COMMENTS AND RESPONSE REPORT

THE PROPOSED UPGRADING OF STORMWATER INFRASTRUCTURE IN ROSEMOOR, GEORGE, WESTERN CAPE.

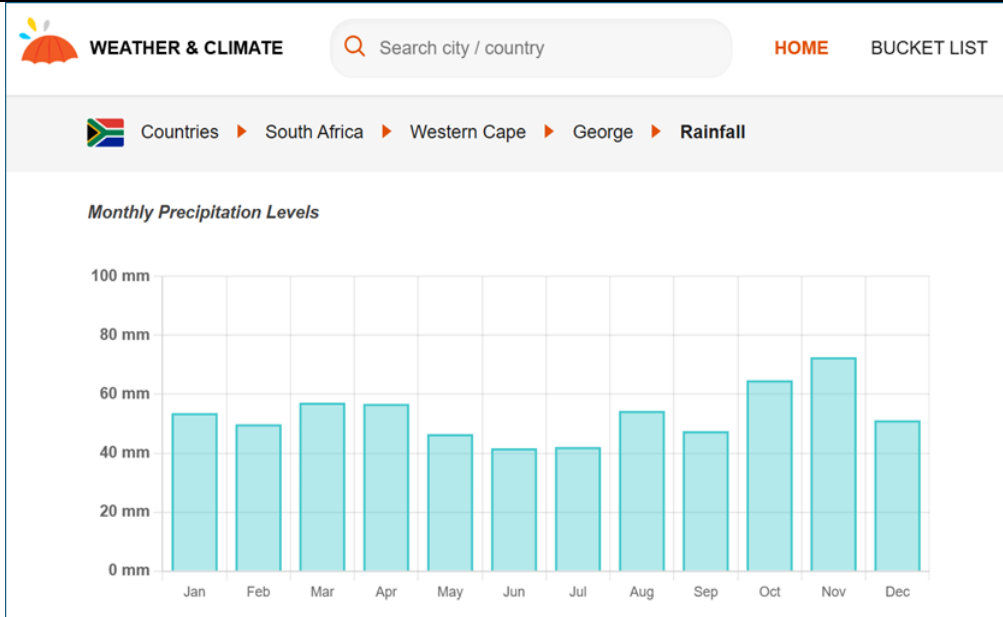
2. The stormwater upgrade follows a severe flooding event. It is recommended that construction takes place during the drier months to minimise the risk of erosion and sedimentation.		While in theory this seems like a good idea, this is not practical in George, as the average precipitation is fairly uniform throughout the year, as seen in the figure below. Additionally, the technicalities associated with funding and appointing contractors to undertake the work does not allow for work to be undertaken in such a manner. Mitigation measures are included in the EMPr to mitigate potential erosion during the construction phase.	11
